Errata IBC Chapter 2 Definitions

Code/Standard: IBC 2021

Applies to following Printings: 1st and 2nd

Posted: January 4, 2022

2113.19

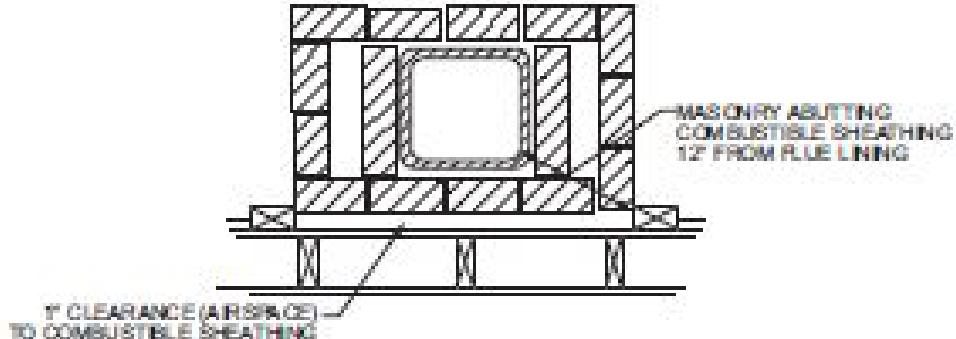
Replace Figure 2113.19 with the following:
